INVESTIGATION REPORT FORM (IRF)

Customer	EPSON PRECISION PHILS. INC.- ASP/EPLB	Attention To	REXEL ALMARIO
Item Code	513238500	Department	PRODUCTION
Item Description	OUTER CARTON BOX	Date of Detection	250410
Job Order Number	JO25-M-01152-34	Section Detected	QA SCREENING 5

ILLUSTRATION OF THE PROBLEM

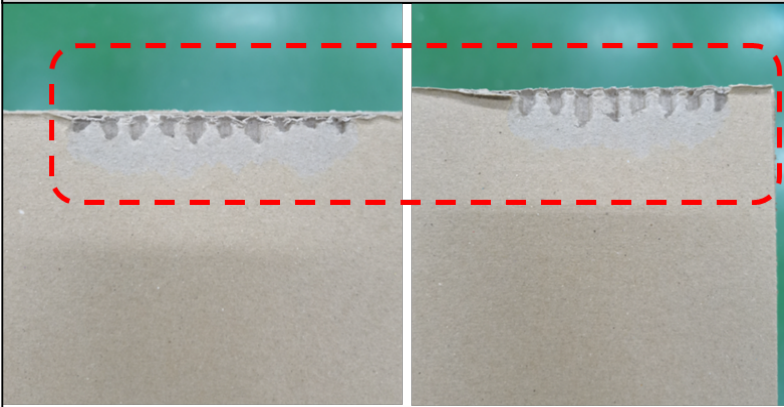
PEEL OFF

ACTUAL: Peel off up to 70mm length
REQUIREMENT: Maximum of 25mm is still Acceptable

WHY 1 : The liner surface of the board was hit on the feed gate of Eqos during running.

WHY 2 : Presence of excess liner and delamination in the edge of the boards.

WHY 1: Assign Packageworld as main supplier of materials for this item. This based on checking and trial run conducted using materials from Sunpack and Packageworld.
